H12442

## DESCRIPTIVE REPORT

*Registry No.* H12442

*Sublocality* Avatanak Strait

**Figure 6 Bottom Detection Artifacts Near Nadir of Reson 7111**

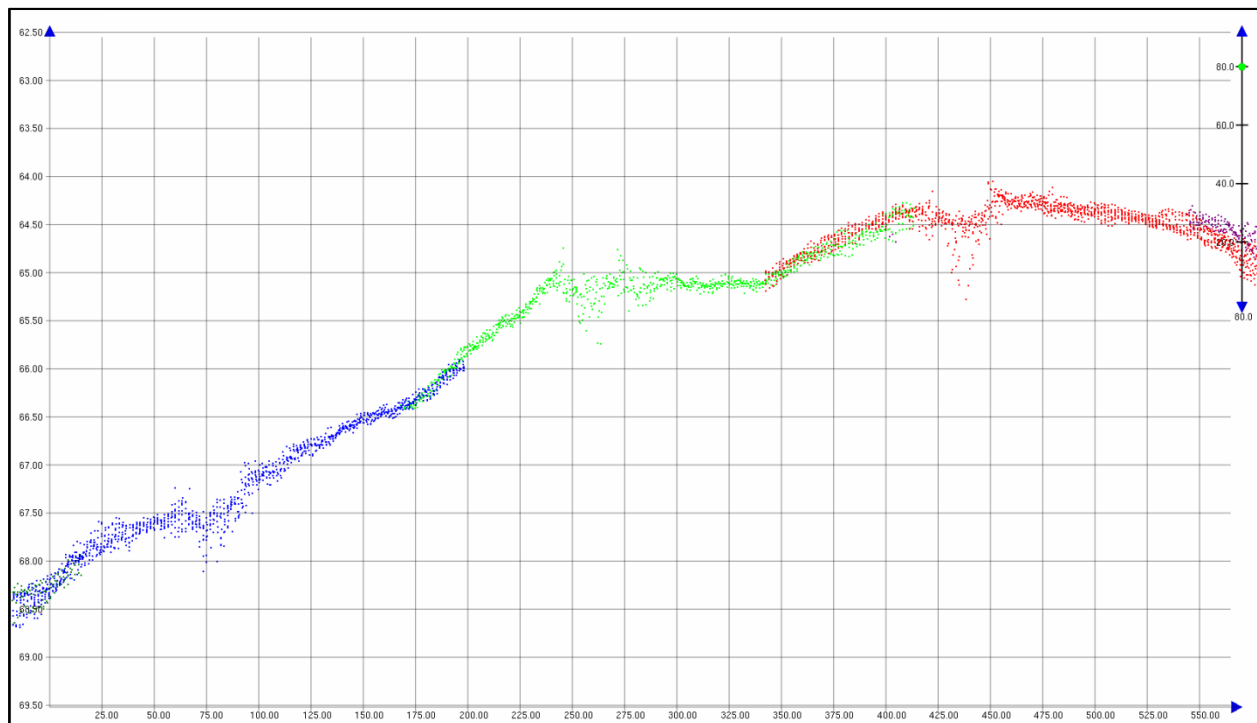
It should be noted however, that during routine processing in CARIS HIPS Swath Editor, survey lines from the F/V Pacific Star's Reson 7111 were found that contained noise due to poor bottom tracking in areas of soft sediment. The bottom detect algorithm in the Reson 7111 may have been affected by the time spreading of the signal return due to sediment penetration close to nadir (**Figure 6**). To mitigate the effects of this sediment penetration, the sonar pulse length was kept low during data acquisition. However, as a result of this bottom detect issue and the rejection of some noisy data, data density dropped below the 5-pings-per-cell requirement in localized areas. Although some localized areas did not meet the 5 pings-per-cell requirement, the overall sheet did meet the 95% requirement for data density, and the CUBE BASE surfaces met IHO Order 1a specifications.<sup>3</sup>

2. The Reson SeaBat 7111 sonar system displayed bottom-detection artifacts near nadir of the multibeam swath. The bottom detection algorithm in the Reson 7111 may have been affected by the time spreading of the signal return due to sediment penetration close to nadir. To mitigate these effects, the sonar pulse length was kept at low settings during acquisition and the artifacts were monitored closely during data processing to ensure all data met IHO Order 1a specifications. See **Figure 6** above.

<sup>3</sup> During office review it was found that the 1 meter Surface exhibited density holidays where good data was rejected by the field. The office reviewer reaccepted the good data to eliminate holidays where possible. The character of the seafloor surrounding the remaining holidays suggest no features exist.

**Figure 7 H12442 Survey Junctions**

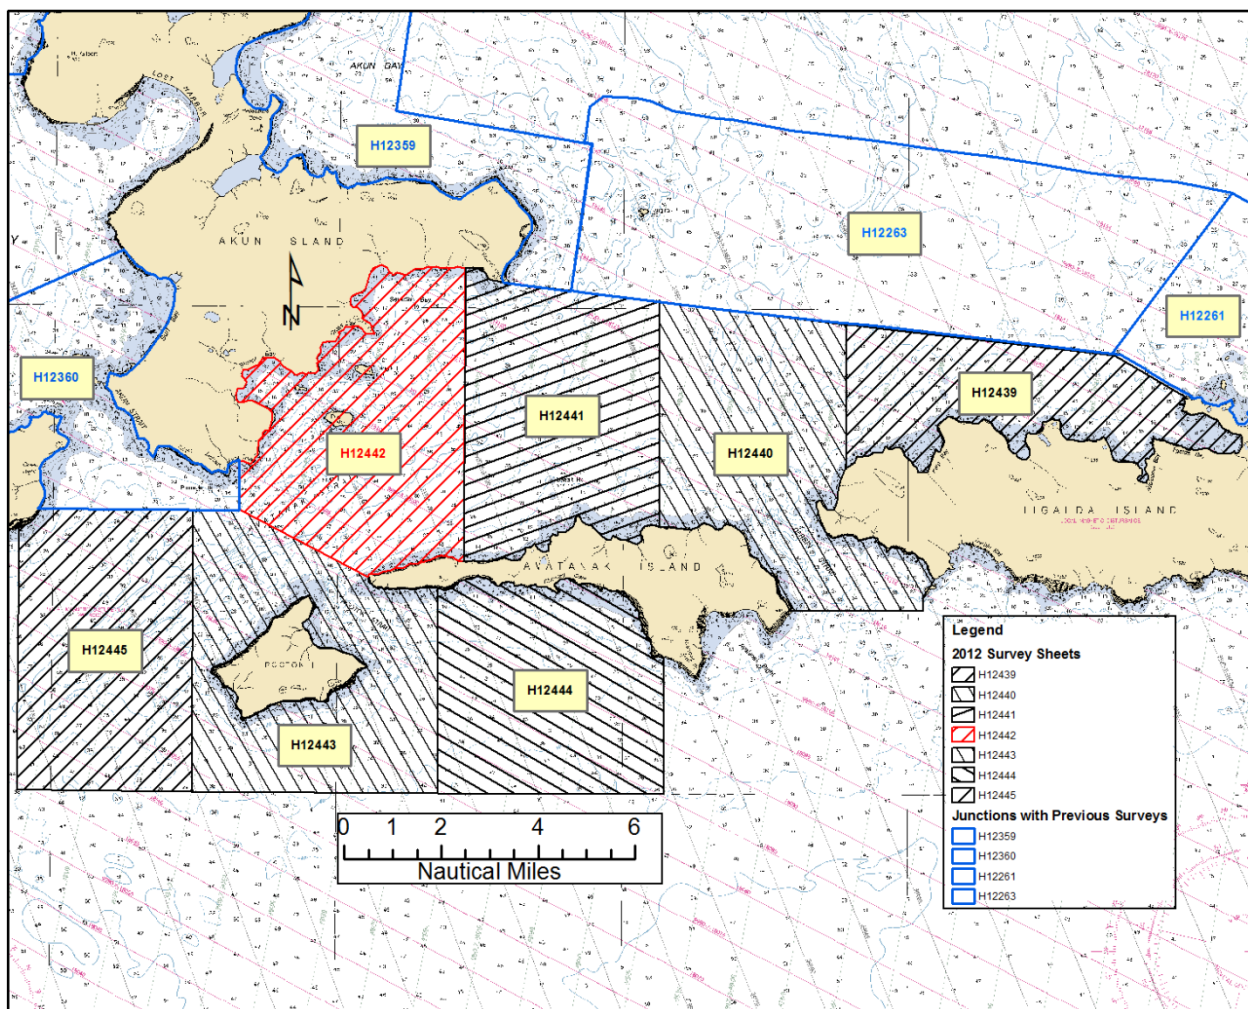
The surveys are in agreement along their common borders. The conformity between H12442 and the bordering survey areas (H12441, H12443, and H12360) was inspected during processing, using CARIS HIPS Subset Editor Routine and the finalized BASE Surfaces. Difference surfaces were also created between H12442 and the bordering survey areas and

confirmed that approximately 82% of the nodes agree to within 0.35m or less. The other 18%, which were in the deeper portions of the sheet, agree to within 0.4m to 0.7m. These differences were usually on the outer edges of the swath, and can be attributed to sound speed error. There is also a noticeable difference in areas with irregular bottom topography. These differences were usually on the nadir portion of the swath, and can be attributed to the bottom detect issue with the Reson 7111. All data, however, were well within the IHO Order 1a allowable error.

**Figure 11 Northern Area of H12442 – Proposed Modifications to Contours**

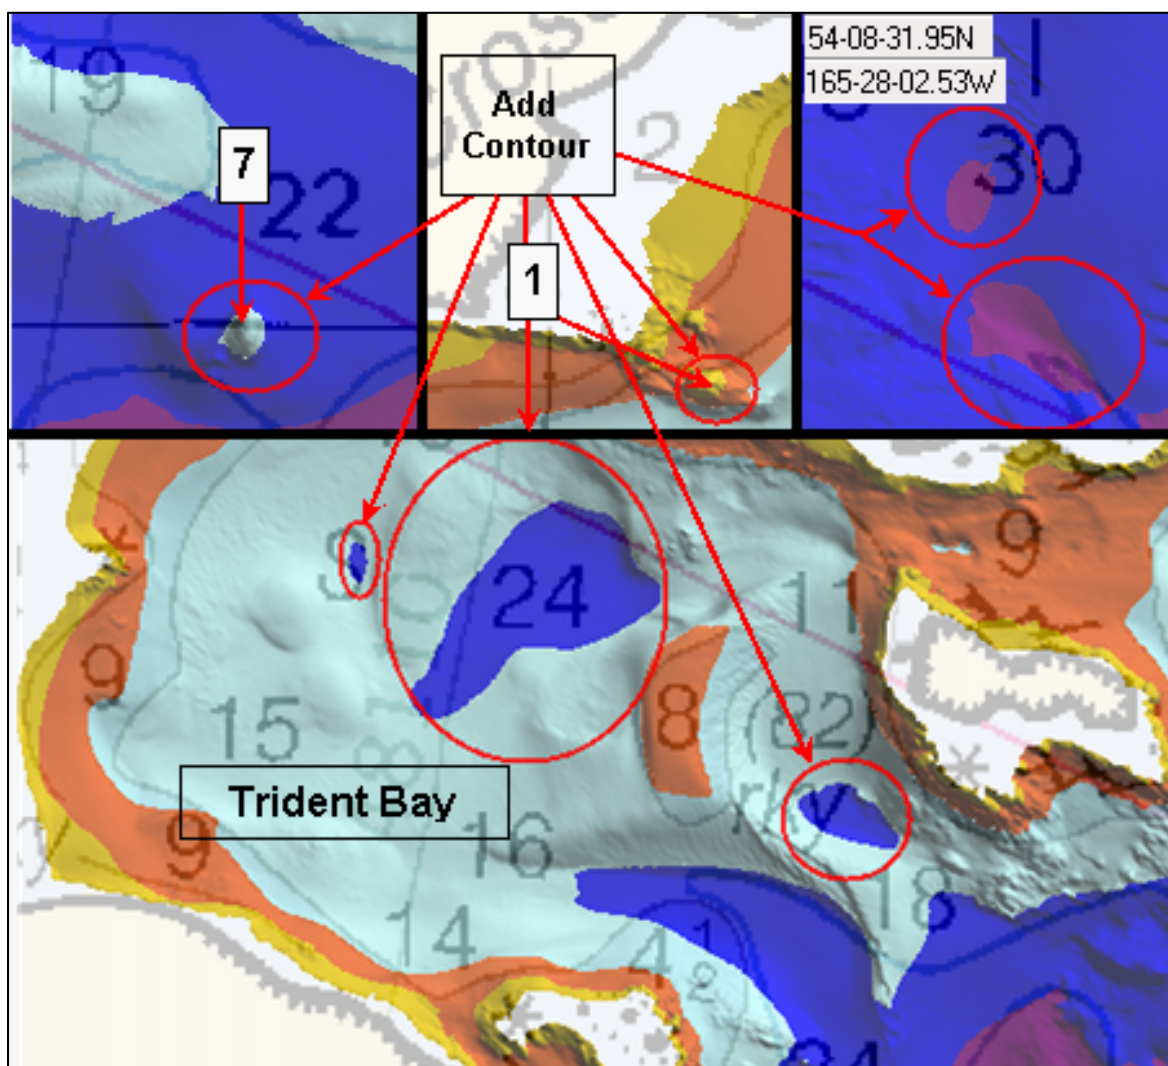
1. Overall, the 100% multibeam coverage established discrepancies between charted and observed contours. Several new contours were discovered throughout the survey area and specifically around items 1, 7, 8, 11, 13, 18, and 19. These new contours and their locations are identified with arrows stating “Add Contour” (**Figure 11** and **Figure 12**).<sup>8</sup>

<sup>8</sup> Contours for the chart update product are derived from the Combined BASE Surface. Final placement of depth curves for the chart are determined based on a number of factors, including soundings selected for compilation and the scale of the chart.
